# Clause 162 Comments

IEEE P802.3ck Task Force

July 2020

## D1.2 Page 154

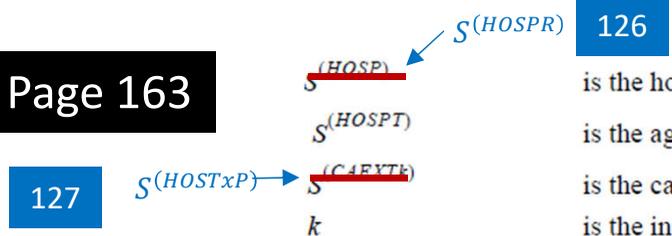
$S^{(HOSPR)}$  220

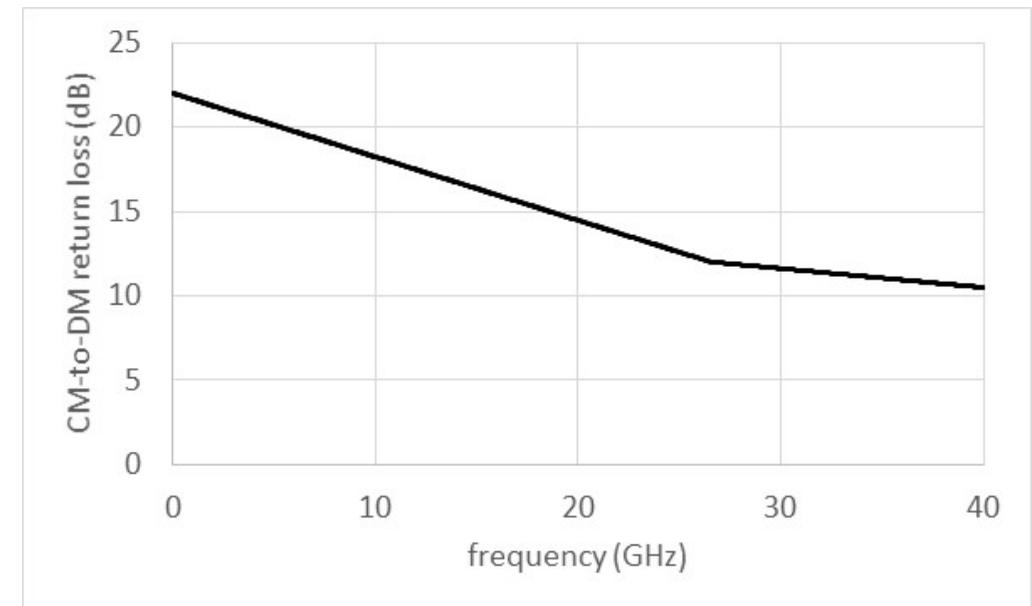
```
Cl 162      SC 162.9.3.1.3      P 151      L 30      # 257
Dawe, Piers      Nvidia
Comment Type T      Comment Status D      Tx electrical
Starting the transmitter up with maximum swing seems bad for two reasons: it suddenly
adds a lot of crosstalk to neighbouring links, before this link has established that the high
swing is needed or desirable; and it may stress the linearity of the receiver. It would be
better to start at a low to medium swing, and the receiver ask to turn it up if it wishes.

SuggestedRemedy
Reduce c(0) in one or both of OUT_OF_SYNC and NEW_IC preset 1. If necessary, create
another row for the traditional neutral at max setting used for testing - but as it seems that
may never be useful in practice, maybe we should avoid that.
Also, in 162.9.4.3.4, reduce the starting amplitude for the training phase in RITT (presently
800 mV peak-to-peak differential "on an alternating 0-3 pattern").
Similarly in 163 as appropriate.

Proposed Response      Response Status W
PROPOSED REJECT

The proposed remedy needs to be complete, including specific proposed values.
```
